STATE OF CONNECTICUT
CONNECTICUT SITING COUNCIL

APPLICATION OF CELLCO PARTNERSHIP DOCKET NO. 434
D/B/A VERIZON WIRELESS FOR A
CERTIFICATE OF ENVIRONMENTAL
COMPATIBILITY AND PUBLIC NEED TO March 28, 2013
RELOCATE AN EXISTING WIRELESS
TELECOMMUNICATIONS FACILITY AT
139 NORTH MAIN STREET, WEST
HARTFORD, CONNECTICUT

AT&T's RESPONSES TO CONNECTICUT SITING COUNCIL INTERROGATORIES

ATTACHMENT 1

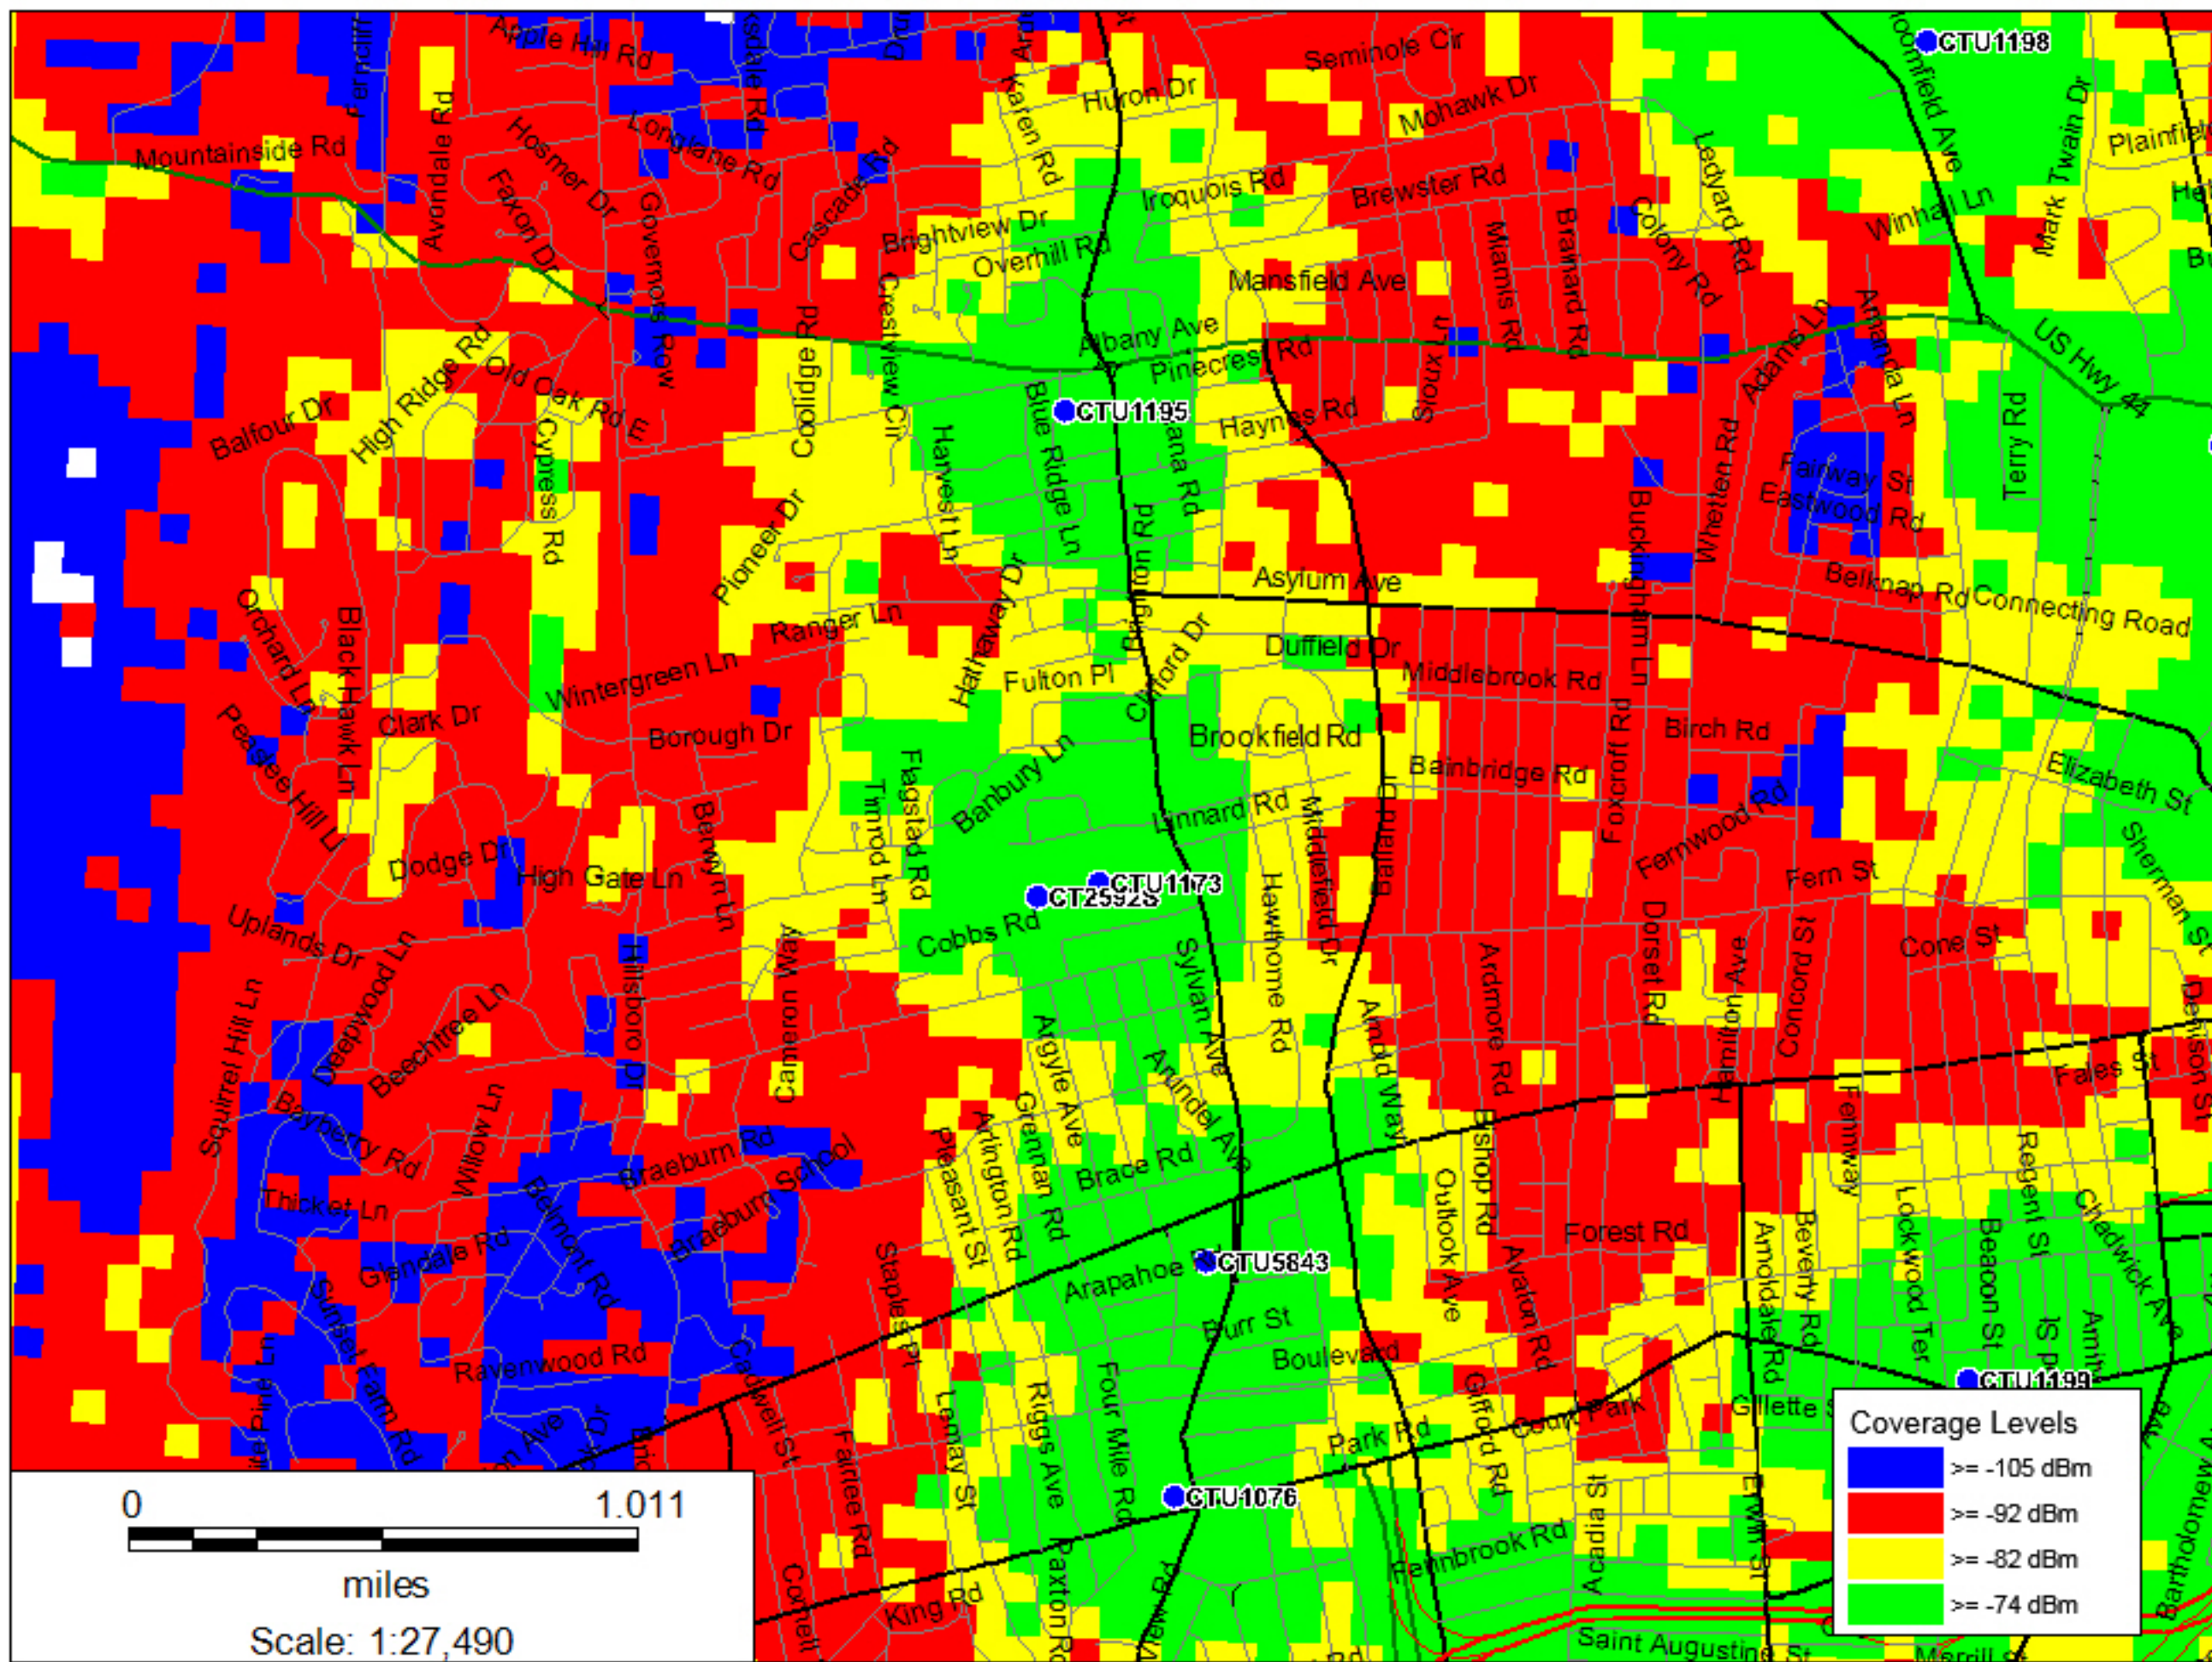
Q4. Provide an existing coverage plot with AT&T's existing facility at Gallaudet Hall.

A4. *A plot depicting existing coverage of AT&T's facility at The Gallaudet Hall with an antenna centerline height of approximately 76' AGL is provided in Attachment 1. Please*

note that all of the plots provided include the existing site name, CTU1173 and the relocated site name CT2592S at ASD.

ATTACHMENT 2

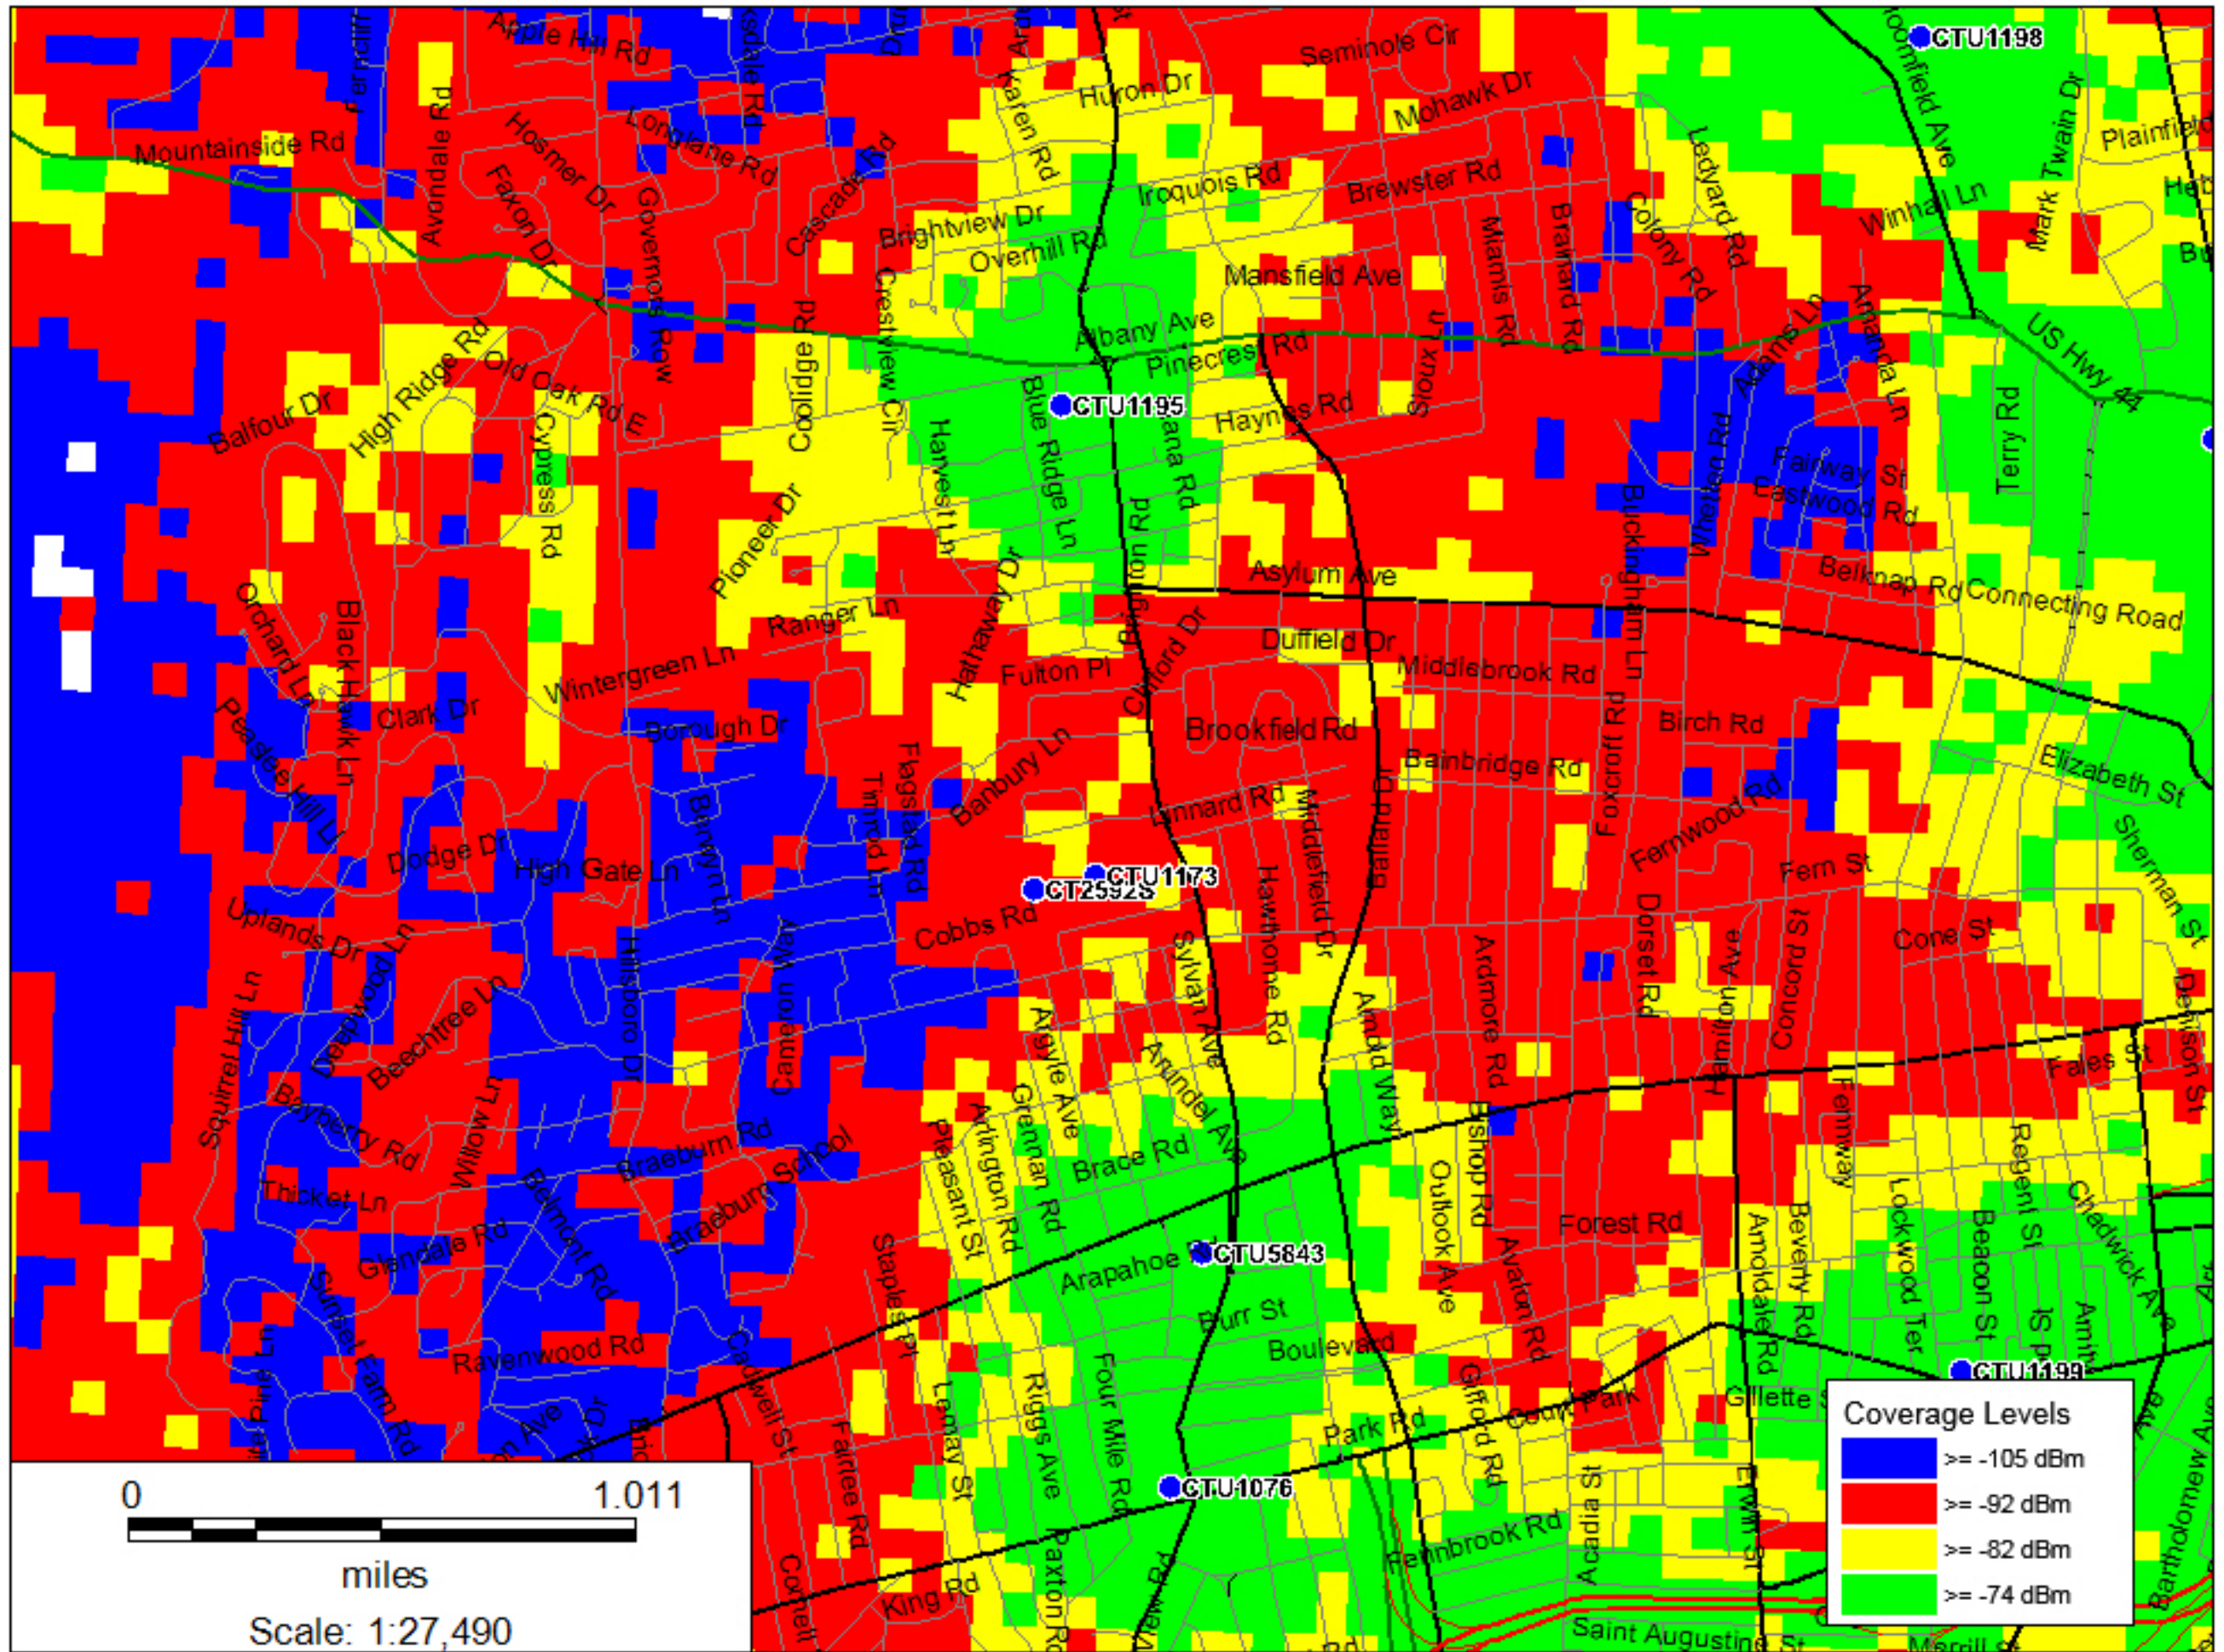
- Q5. Provide an existing coverage plot without the existing facility at Gallaudet Hall or the proposed clock tower. In other words, provide an existing coverage plot to illustrate the coverage gaps that would result from having no AT&T facility at American School for the Deaf (ASD).

Q9. Would there be handoff issues without a facility at ASD? Explain.

- A5. *The plot included in Attachment 2 illustrates the coverage gaps that would result with no AT&T facility at the ASD. As shown in the attached plot, without a facility at the ASD, gaps in reliable service would result along North Main Street and the surrounding area. (Please note that all of the plots provided include the existing site name, CTU1173 and the relocated site name CT2592S at ASD.)*

A9. *Yes. As shown in the plot included in Attachment 2, a coverage gap would result without a facility at ASD. This plot also shows that the gap is too large to allow reliable handoff between AT&T's existing sites to the north (CTU1195) and south (CTU5843) of ASD. (Please note that all of the plots provided include the existing site name, CTU1173 and the relocated site name CT2592S at ASD.)*
